UH-1, AH-1 T53 Engine...

Power Plant Filter Update

**One assembly
replaces all
7 filters**

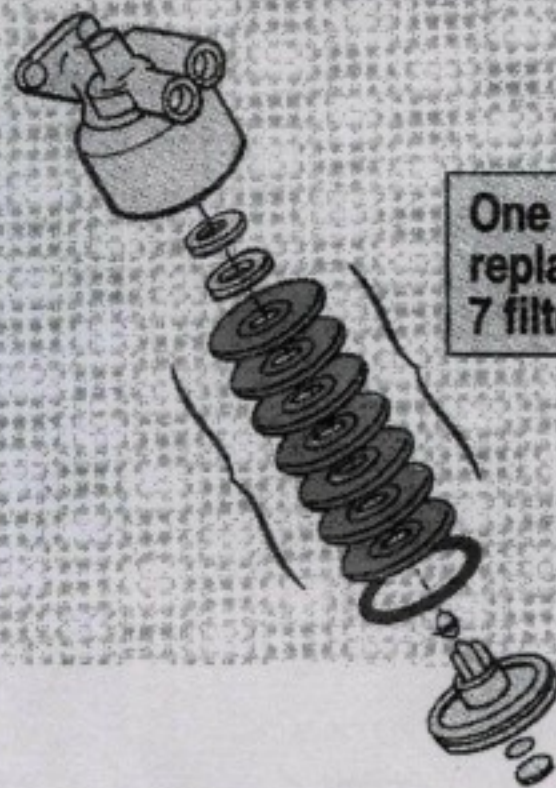
Order the fluid filtering disk, Item 9 of Fig 47 of TM 55-2840-233-23P, with NSN 2945-01-115-9547... and order just one!

The TM tells you to order 7 of the old disks, NSN 2945-00-736-3978. But the new disk is an assembly. One will do the job that it took 7 of the old disks to do.
